Assessing Annual Risk of Vehicles Hit by a Rainfall Induced Landslide: A Case Study on Kennedy Road in Wan Chai, Hong Kong

Response to Review Comments

Figure 13. Impact of annual failure probability of the slope on annual societal risk

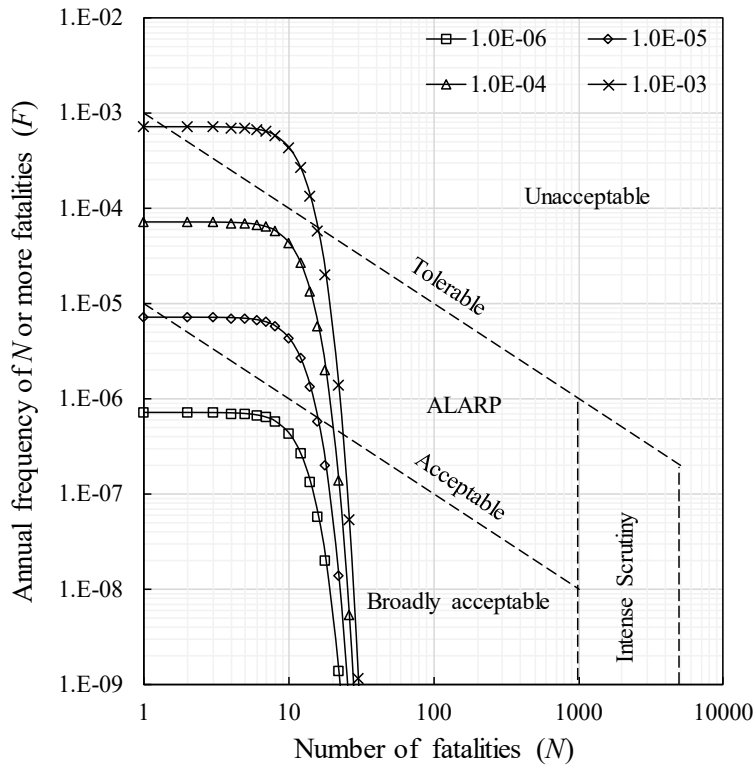
However, I think that a good contribution of your research can be to support establishing new guidelines for highways design for purposes of roadway safety in terms of landslide risk reduction hitting vehicles & persons. For this, the methodology must be more detailed looking for include some uncertainties involve in the process providing innovative or novelty assessment processes or methods. The authors should consider that include solutions to the assumptions and uncertainties involve in the processes, omitted in other research can be the innovative level required for a relevant paper.

“Fig. 13 shows the how the societal risk for all types of vehicles changes as the annual failure probability of the slope changes. As can be seen from this figure, when the failure probability of the slope is smaller than 1.0×10^{-4} , the societal risk will be in the ALARP region. If the failure probability of the slope is further reduced to 1.0×10^{-6} , the societal risk will become acceptable. Hence, reducing the annual failure probability of a slope is an effective means to reduce the risk of the slope. In practice, the annual failure probability of a slope under rainfall can be reduced through the use of engineering measures such as structural reinforcement. To assess the effect of such measures on the failure probability of the slope, physically-based methods shall be used for hazard probability analysis.”

Figure 4. Event tree of evaluating the annual risk of the type j vehicle hit by the landslide

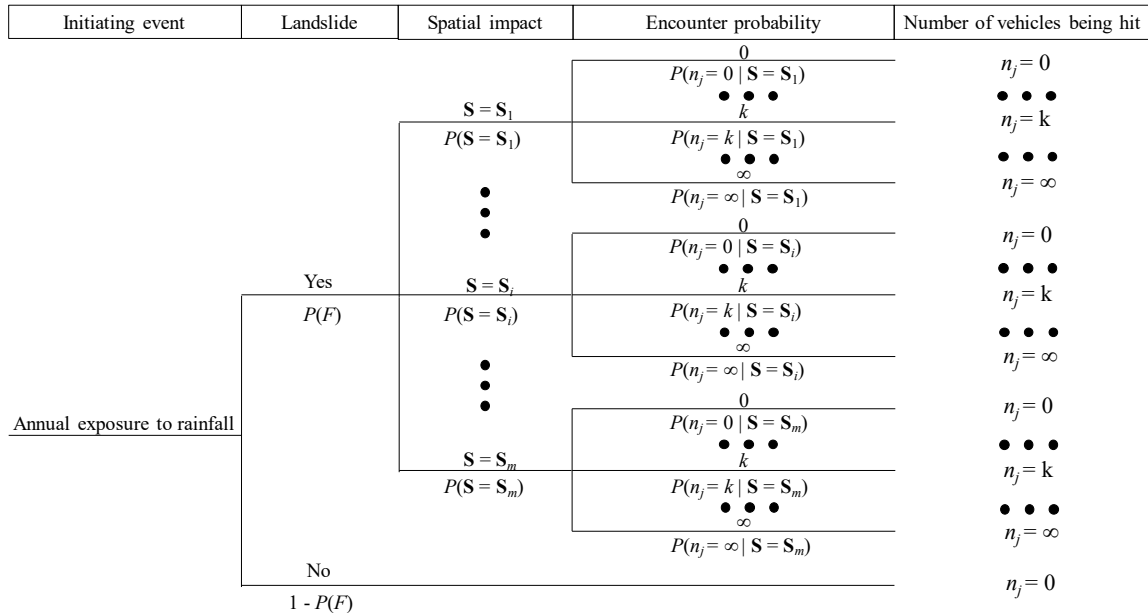
Review comment 6: *Methods must include an innovative formulation proposed by the authors, maybe the key of this could lies in the incorporation of those aspect omitted in other studies. Moreover, the limitations of the proposed model should be more explicit in the main text and discussion of them may be incorporate. A figure containing a graphical workflow is convenient. The authors are suggested to read and take into account more high-quality papers about this particular case.*

Review comment 13: [Page 5, Line 99-100] *It should not be sufficient only a slope failure, because the sliding mass might not reach the road, even a vehicle. Why? because that probability of reach de road depends of slope geometry, geotechnical parameters, etc... then how you could explain and include this consideration in your model?*

Authors’ reply: Thank you for your suggestion. We have clarified the novelty of the suggested method in the revised manuscript, as described in our response to Review comment 1. We have also illustrated the limitations of the proposed model, as described in our response to Review comment 1. In addition, we have provided an event tree model to illustrate the workflow, and revised the description of the method suggested in the paper along with the event tree as follows [Lines 102-120]:

“Fig. 4 shows the event tree model employed in this study to assess the risk of rainfall-induced landslide hitting type j vehicles. As can be seen from this figure, if the slope does not fail in a year, there will be not spatial impact, and the number of type j vehicles being hit is zero. Let $P(F)$ denote the annual probability of slope failure. If the slope fails, its spatial impact, which can be characterized by the width of the landslide mass and the runout distance of the landslide mass, is also uncertain. In general, the spatial impact of the landslide depends on factors like slope geometry, soil profile, soil strength parameters, and water content in the soil mass. The spatial impact can be evaluated using physically-based methods or statistically-based methods, and will be discussed later in this paper. Suppose there are m possible spatial impacts and let $P(\mathbf{S} = \mathbf{S}_i | F)$ denote the probability that the spatial impact is \mathbf{S}_i when the landslide occurs. For a given spatial impact, the number of type j vehicles being hit is also uncertain. Let n_j denote the number of the type j vehicle being hit by the landslide. Let $P(n_j = k | \mathbf{S} = \mathbf{S}_i)$ denote the encounter probability that k type j vehicles will be hit by the landslide when the spatial impact is \mathbf{S}_i . If the landslide mass cannot reach the road for the case of $\mathbf{S} = \mathbf{S}_i$, the spatial impact is zero, which can be denoted as $P(n_j = 0 | \mathbf{S} = \mathbf{S}_i) = 1$.

Based on the event tree as shown in Fig. 4, the annual probability of k type j vehicles being hit by the landslide is $P(F) \times P(S = S_i | F) \times P(n_j = k | S = S_i)$ when the spatial impact of the landslide is S_i , and expected number of type j vehicles being hit corresponding to such a scenario is $k \times P(F) \times P(S = S_i | F) \times P(n_j = k | S = S_i)$.”

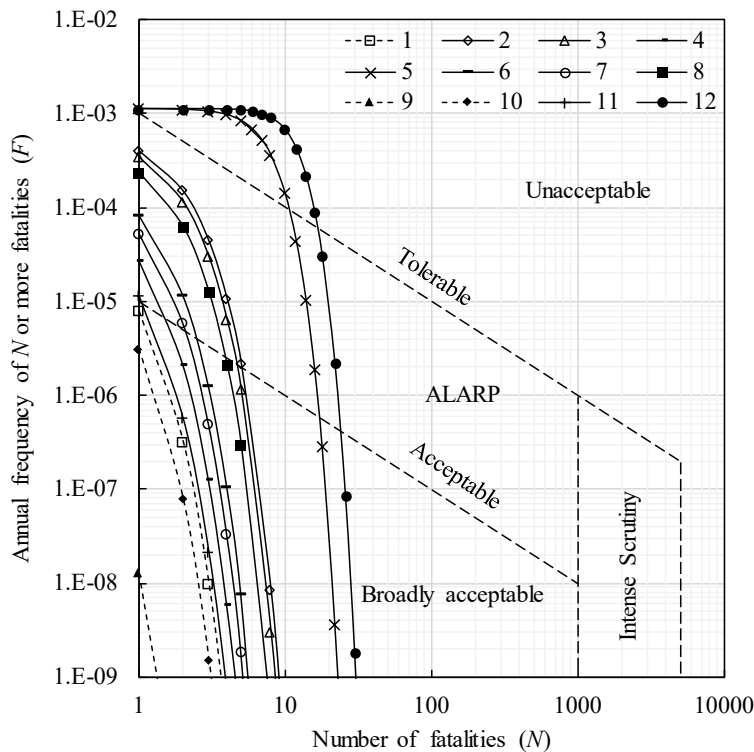
Review comment 24: [Page 11, Line 232] *It is suggested to comment if these values correspond to high or low risk values according some risk scale.*

“The society is less tolerant of events in which a large number of lives are lost in a single event, than of the same number of lives are lost in a large number of separate events, which can be measured through societal risk (Cascini et al., 2008). In Hong Kong, the societal risk is measured through F-N relationship (GEO, 1998), as shown in Fig. 11. In this figure, the horizontal axis denotes the number of fatalities, and the vertical axis denotes cumulative annual frequency of the number of fatalities. There are four regions in this figure, i.e., the region in which the risk is unacceptable, the region in which the risk is broadly acceptable, the region in which the risk should be made as low as reasonably practicable (ALARP), and the intense scrutiny region. To assess the societal risk of the landslide, the relationship between the number of fatalities and the probability of such an event should be established. When the traffic flow is a Poisson process, the passengers in the traffic flow can also be modeled through Poisson process. For example, the mean rate of occurrence of passengers in type j vehicle is $\lambda_{pj} = n_{pj}\lambda_j$ where n_{pj} is the passenger capacity of type j vehicles and λ_j is the mean rate of occurrence of type j vehicles. Let n_{jp} denote the number of people being hit by the landslide. Using equations similar to Eqs. (14) and (15), the chance of k passengers in type j vehicles hit by the landslide for a given spatial impact can also be calculated, which is denoted as $P(n_{jp} = k | \mathbf{S} = \mathbf{S}_i)$. The annual chance of k passengers in type j vehicles hit by the landslide can be calculated as:

Fig. 11 shows the relationships between the number of people being hit by the landslide and the annual probability such an event occurs for different types of vehicles. As can be seen from this figure, the risk associated with type 5 vehicles (private cars) is greatest and unacceptable. The risk associated with type 1 vehicles (private buses), type 9 vehicles (special purpose vehicles), and type 10 vehicles (government vehicles) are in the acceptable region. The risk associated with the rest types of vehicles are in the ALARP region. Indeed, the people being hit by the landslide on 8 May 1992 was a person in the private car.

Figure 1. Location of the landslide studied in this paper

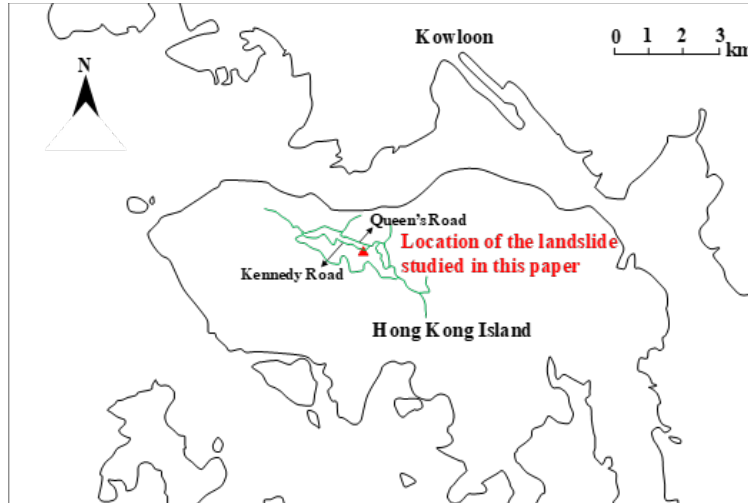
Review comment 5: *Abstract must be revised once all modification have been made. Some Figures must be re-designed for a relevant scientist paper publication.*

Review comment 31: [Page 23, Line 448] It is suggested a convenient figure, preferably with own authorship. As the figure is, it is not recommended for a scientific publication.

Authors' reply: Thank you for your advice. The figure has been re-designed in the revised manuscript as follows:

Figure 2. Typical cross section of the slope and the occurred landslide studied in this paper

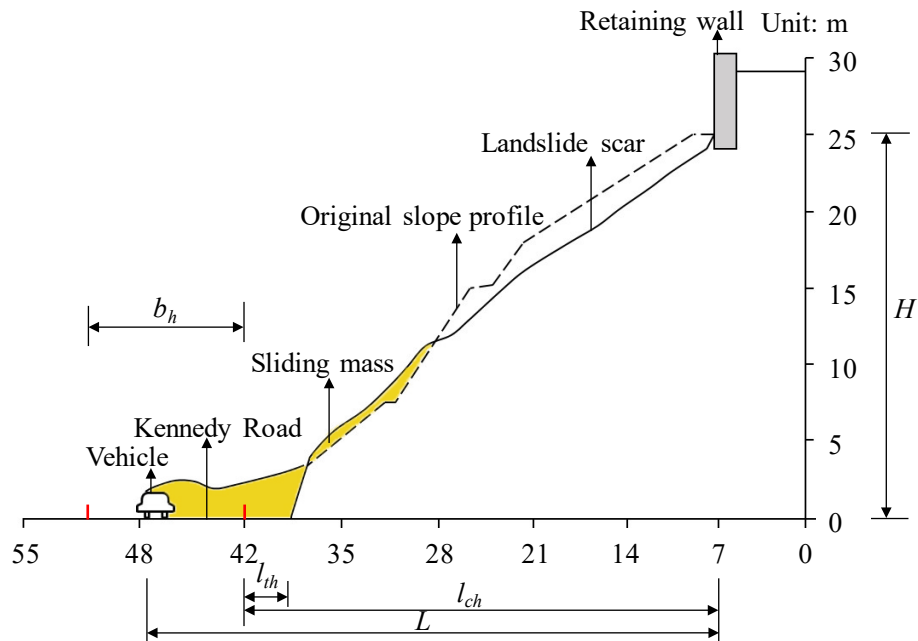
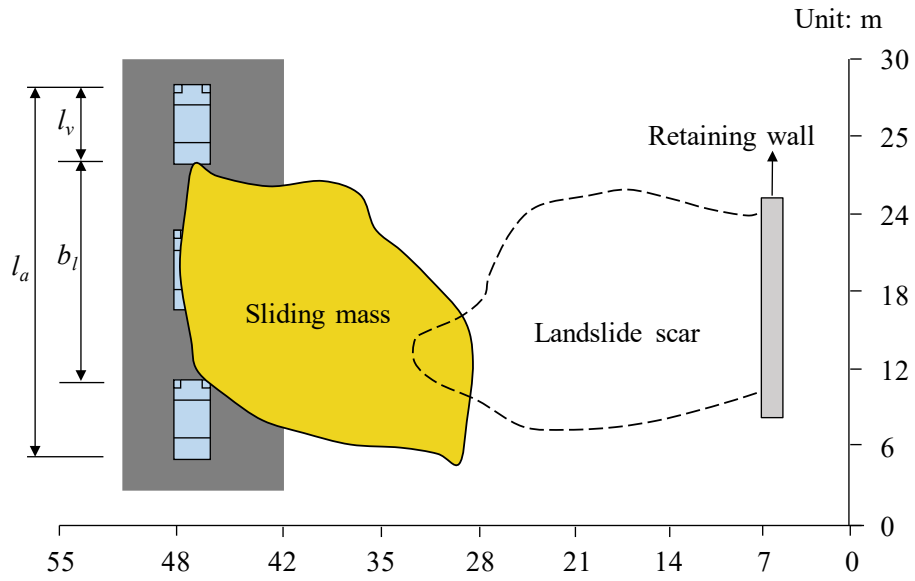
Review comment 32: [Page 24, Line 452], [Page 25, Line 456] It is suggested a better figure. As the figure is, it is not proper for a scientific publication.

Authors' reply: We have re-designed the figures of the slope based on your advice as follows:
